UNITED STATES PATENT AND TRADEMARK OFFICE

APPLICATION NO.	FILING DATE	FIRST NAMED INVENTOR	ATTORNEY DOCKET NO.	CONFIRMATION NO.
10/779,700	02/18/2004	Lin I-Yung	OP-092000407	8957
7590	11/15/2005		EXAMINER	
Yi-Wen Tseng 4331 Stevens Battle Lane Fairfax, VA 22033			CHANDRAN, BIJU INDIRA	
			ART UNIT	PAPER NUMBER
			2835

Office Action Summary

DETAILED ACTION

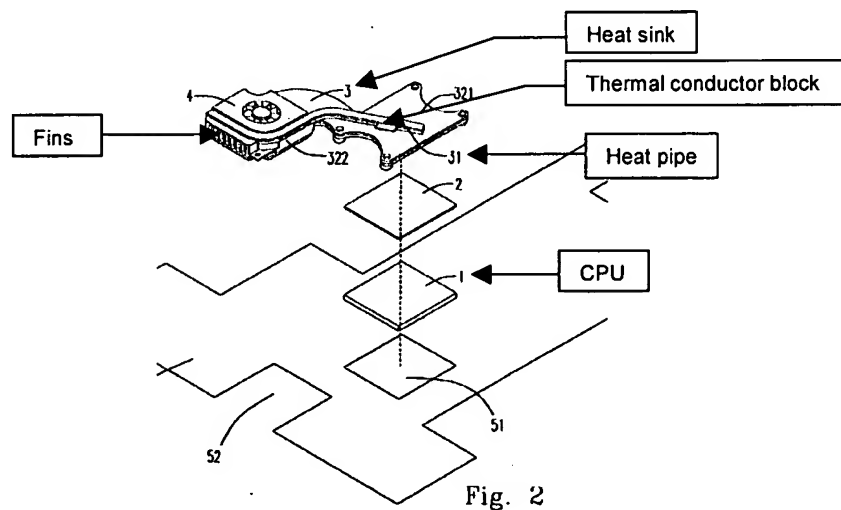
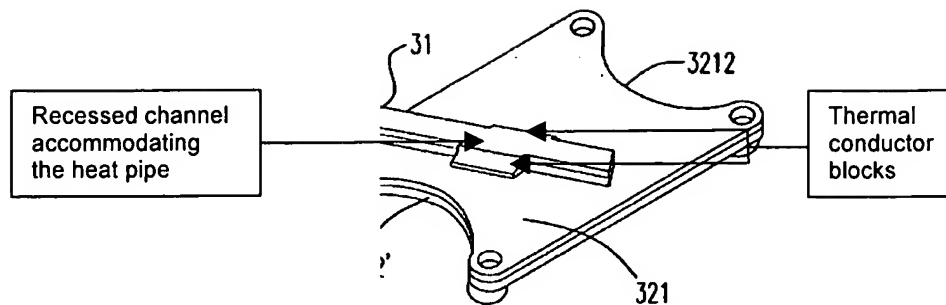
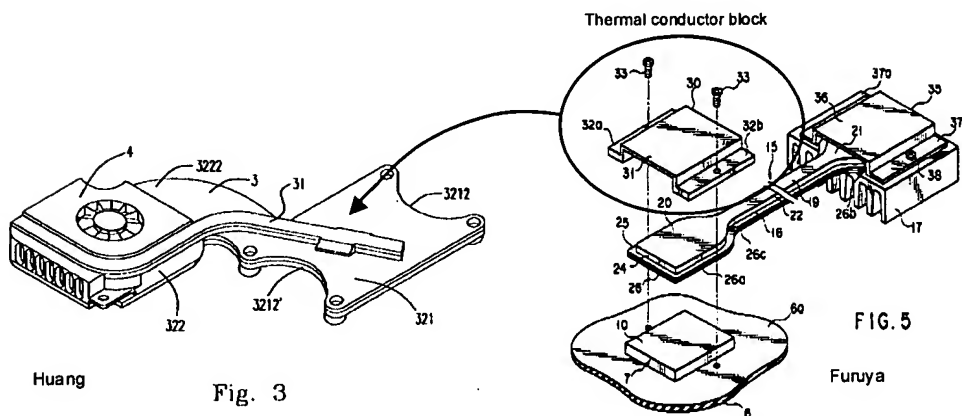
- Regarding claim 1, Huang discloses a heat dissipation structure, comprising: a heat sink (3), installed on a heat generating electronic device (1); at least one heat pipe (31), having a proximal end located on the heat sink and a distal end extends outside of the heat sink, wherein the heat pipe includes a wick structure and a working fluid therein (a heat pipe by definition is a heat transfer device with a sealed metal tube having an inner lining of wick like material and a small amount of liquid. See, for example, the definition of heat pipe in *McGraw-Hill Dictionary of Scientific and Technical Terms, Sixth edition*); a set of fins connected to the distal end of the heat pipe (marked in figure); at least one thermal conductor block installed on the heat sink and adjacent to the heat pipe (marked in figure), the thermal conductor block is operative to store thermal energy.

- Regarding claim 2, Huang further discloses that the heat sink further comprises an extension towards the set of fins (see figure).
- Regarding claim 3, Huang further discloses that the extension extends over the set of fins to form a guide portion.

- Regarding claim 4, Huang further discloses that the electronic device included a central processing unit (marked '1', paragraph 0020).

- Regarding claim 5, Huang further discloses two thermal conductor blocks at two sides of the heat pipe.
- Regarding claim 6, Huang further discloses that the thermal conductor includes a recessed channel for accommodating the heat pipe therein (see figure).
- Regarding claim 11, Huang further discloses that the thermal conductor block is fabricated in a form of reinforcing rib.
